**PLANNING & PUBLIC
WORKS**

Front Yard Setback Variance: Joseph and Ana Parker Application No. 1014284

Project Proposal

Building Elevations

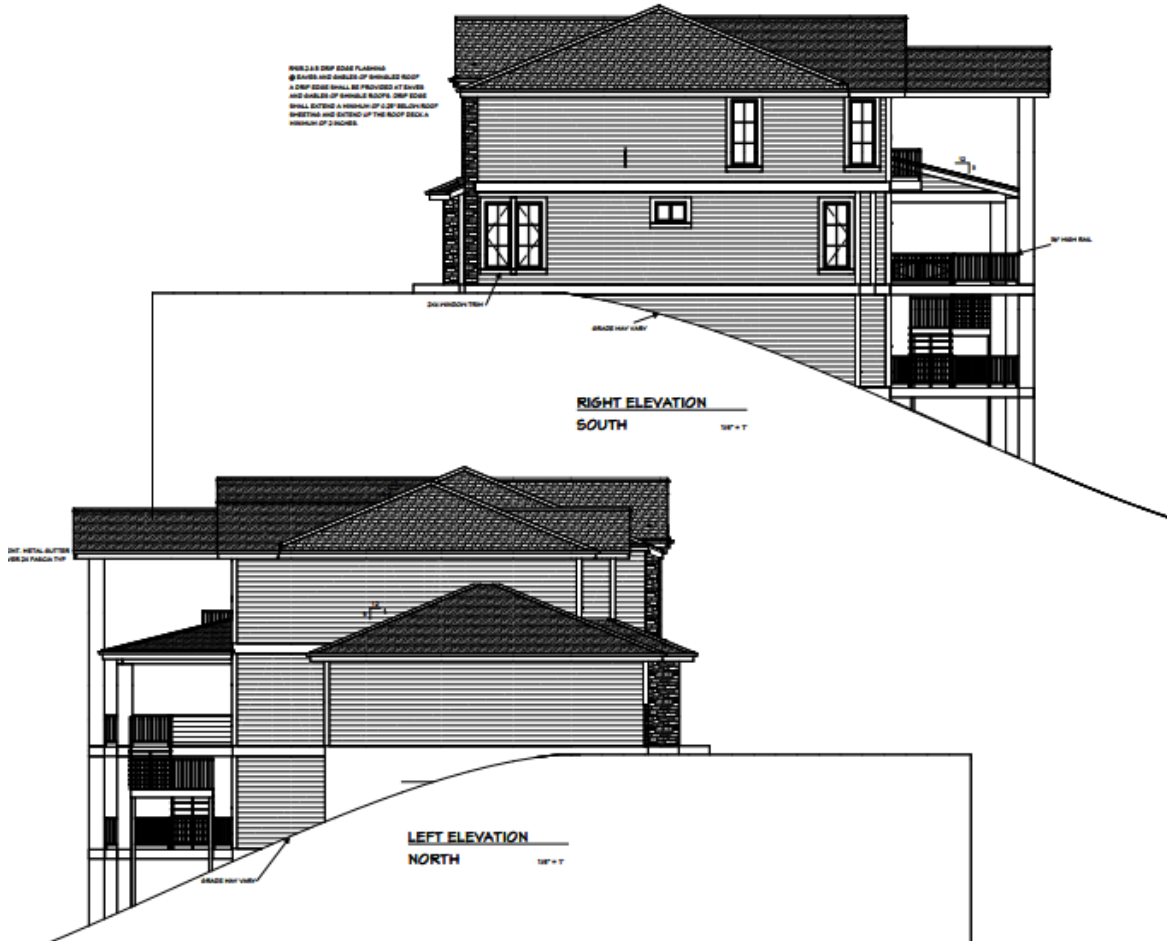
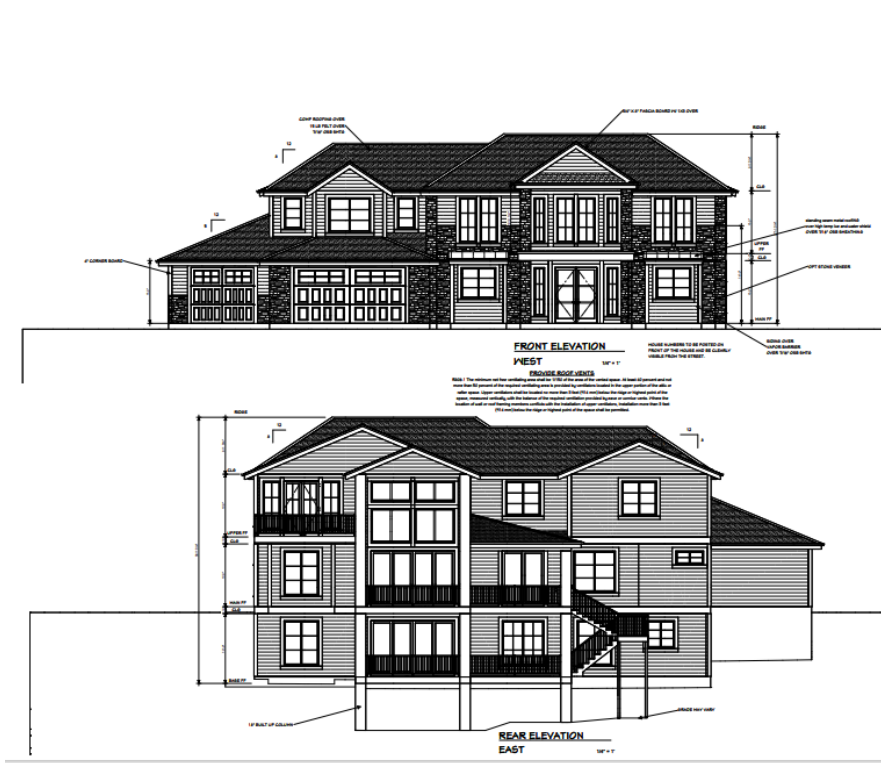
- The proposed building elevations on the east side (back side of the house) show several outside covered decks which could be reduced in size, still allow a view, and allow the home to be closer to compliance with the front yard setback.
